## DEADLINE 5 SUBMISSION

M54-M6 LINK ROAD  
M6 DIESEL SITE AT SAREDON

<b>Project</b>	M6 Diesel site at Saredon & M54-M6 link road		
<b>Document Number</b>	SAR-BWB-GEN-XX-RP-TR-0007	<b>BWB Ref</b>	NTH2442
<b>Author</b>	Simon Hilditch	<b>Status</b>	S2
<b>Checked</b>	Alan Darby	<b>Revision</b>	P1
<b>Approved</b>	Peter Selfe (M6 Diesel)	<b>Date</b>	19.01.2021

Figure 1: SCC proposed weight limit (taken from SCC deadline 4 submission [REP4-042]).

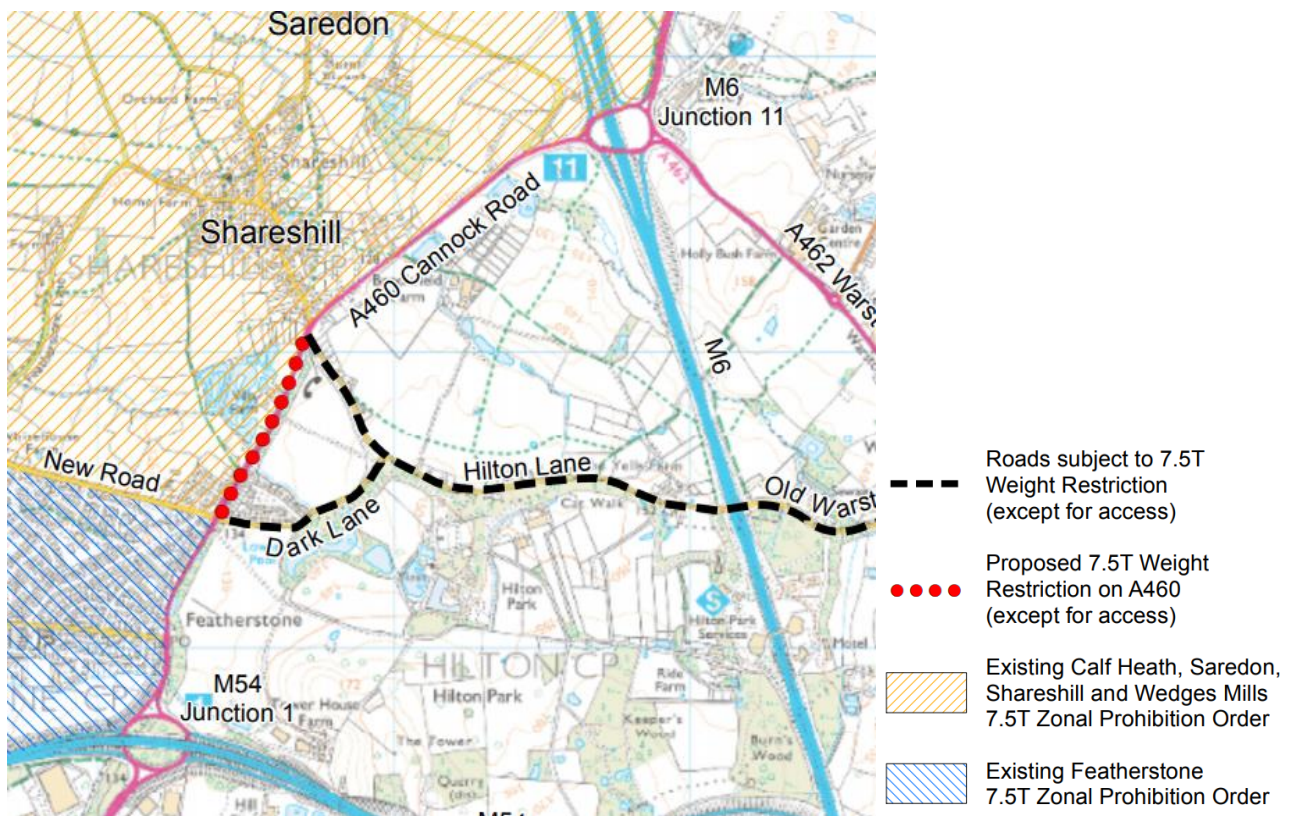
- 2.4 SCC are proposing that the 7.5T weight limit covers the section of the existing A460 between Hilton Lane and Dark Lane as shown on **Figure 1** below.

- 2.5 For HGV drivers leaving the M6 Diesel site, seeking M54 J1, their satellite navigation system (and road user knowledge if they have used the facility previously) will indicate that they should turn left. Even if signage were to be provided at the exit many drivers would still turn left onto the A460 and our experience from other schemes shows that this will indeed be the case.

- 2.6 At the Hilton Lane junction, HGV drivers would then be faced with all roads having a 7.5T weight restriction as limits would exist on Hilton Lane, Church Road and the existing A460. At this point HGV drivers would therefore have no other legal option but to perform a U-turn on the existing A460. We do not believe that this would be a safe manoeuvre for HGV drivers and could be of detriment to the safety of other road users.

- 2.7 If HGV drivers decide that it is unsafe or impracticable to perform such a manoeuvre then they will be likely to contravene the weight restriction and continue to travel along the existing A460.

- 2.8 As to HGV drivers coming from the south, they are unlikely to be aware of the extent of the HGV restriction and are therefore likely to consider the “except for access” provision to apply and would continue through to M6 Diesel. To minimise the likelihood of this and to encourage HGV drivers to travel via M6 junction 11, if the weight limit were to be imposed, then we would request HGV signage for M6 Diesel to be installed on the M54 to M6 link road through M54 J1 and on the approach to M6 J11. This would be in addition to the signage set out in our proposed protective provisions [REP4-055].

- 2.9 We therefore consider that the imposition of a 7.5T weight limit as proposed by SCC would be unworkable with many HGVs breaching the restrictions. Furthermore, it is very likely to result in road safety problems as HGVs would have to perform a U-turn to avoid breaching the weight limit.

- 2.10 To conclude, based on the reasons set out above, M6 Diesel strongly objects to the SCC proposal.
